RS-20-016 April 13, 2020 10 CFR 50.90

> Clinton Power Station, Unit 1 Facility Operating License No. NPF-62 <u>NRC Docket No. 50-461</u>

- Subject: Application to Revise Technical Specifications to Adopt TSTF-566, "Revise Actions for Inoperable RHR Shutdown Cooling Systems"
- Reference: Letter from Victor G. Cusumano (U.S. NRC) to Technical Specifications Task Force, "Final Safety Evaluations of Technical Specifications Task Force Traveler TSTF-566, Revision 0, 'Revise Actions for Inoperable RHR Shutdown Cooling Subsystems," dated February 21, 2019

APPLICABILITY: MODE 4.

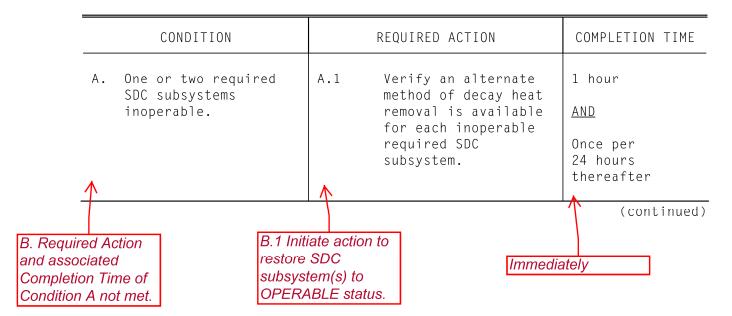
CONDITION		REQUIRED ACTION	COMPLETION TIME
₽. C.	No required SDC subsystem in operation. <u>AND</u> No recirculation pump in operation.	B.1 C.1	Verify reactor coolant circulating by an alternate method.	1 hour from discovery of no reactor coolant circulation <u>AND</u> Once per 12 hours thereafter
		AND B.2 C.2	Monitor reactor coolant temperature and pressure.	Once per hour

APPLICABILITY: MODE 3, with reactor steam dome pressure less than the RHR cut in permissive pressure.

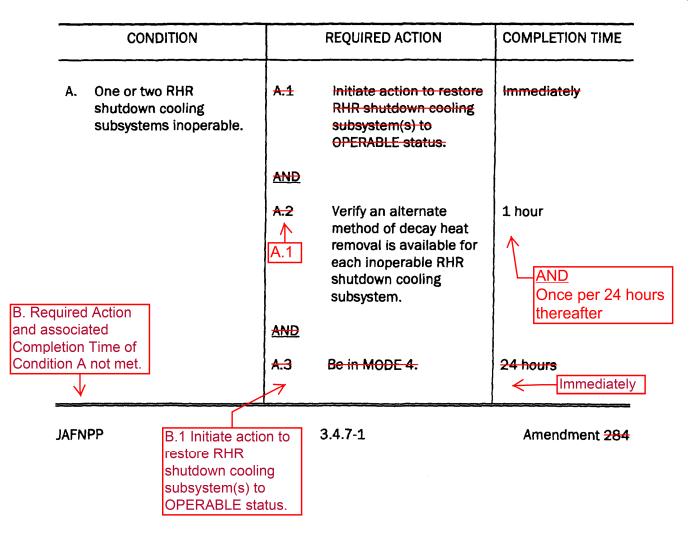
Separate Condition entry is allowed for each RHR shutdown cooling subsystem.

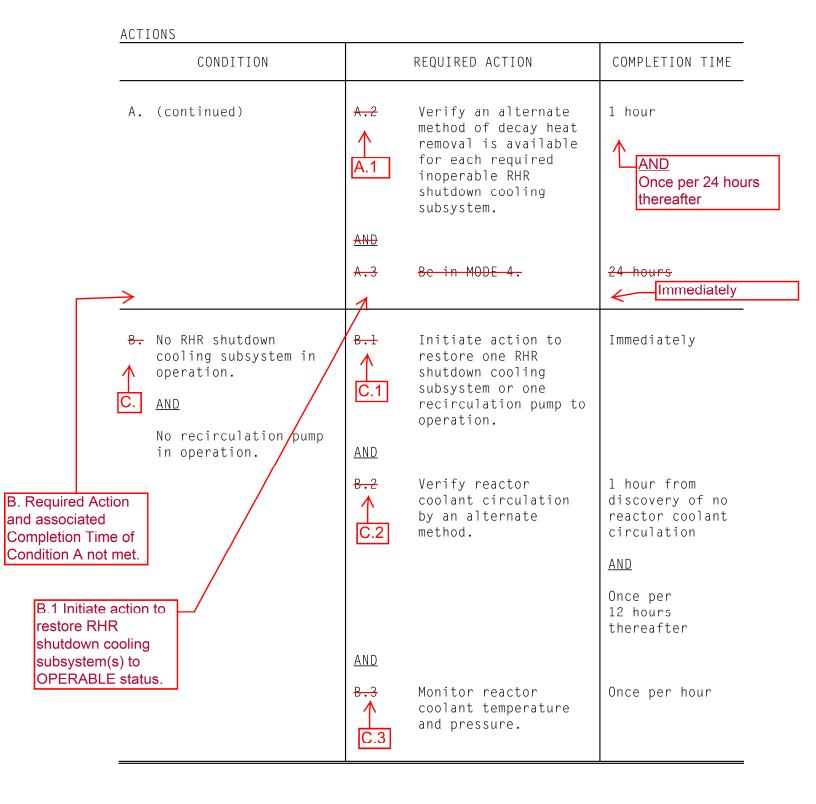
CONDITION		REQUIRED ACTION		COMPLETION TIME	
Α.	One or two required RHR shutdown cooling subsystems inoperable.	A.1	Initiate action to restore required RHR shutdown cooling subsystem(s) to OPERABLE status.	Immediately	
		<u>and</u>			
				(continued)

3.4.8 Residual Heat Removal (RHR) Shutdown Cooling System-Cold Shutdown

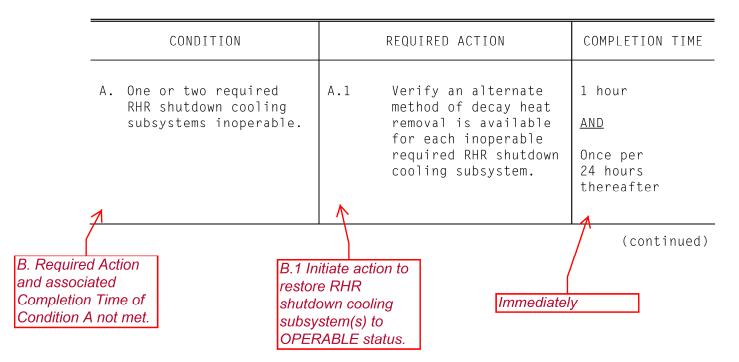
Separate Condition entry is allowed for each RHR shutdown cooling subsystem.

APPLICABILITY: MODE 4.

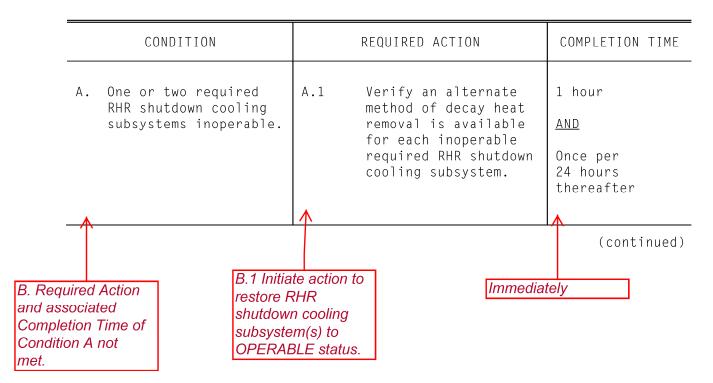
CONDITION		REQUIRED ACTION	COMPLETION TIME
 B. No RHR shutdown cooling subsystem in operation. C. AND No recirculation pump in operation. 	B.1 ↑ C.1	Verify reactor coolant circulating by an alternate method.	1 hour from discovery of no reactor coolant circulation <u>AND</u> Once per 12 hours thereafter
	AND B.2 C.2	Monitor reactor coolant temperature and pressure.	Once per hour
